Front Door Lock Grommet Retrofit

2019 - 2021 (DT) RAM 1500 Pickup

Fig. 1
Design Difference

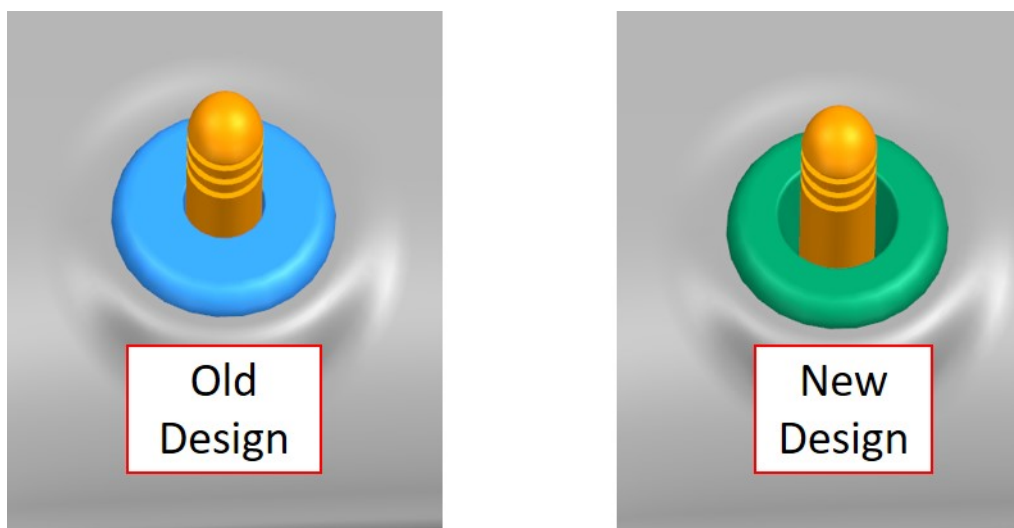
This bulletin involves retrofitting the front door lock grommet with a new part to allow the door lock to be recessed into the grommet on both front doors (Fig. 1).
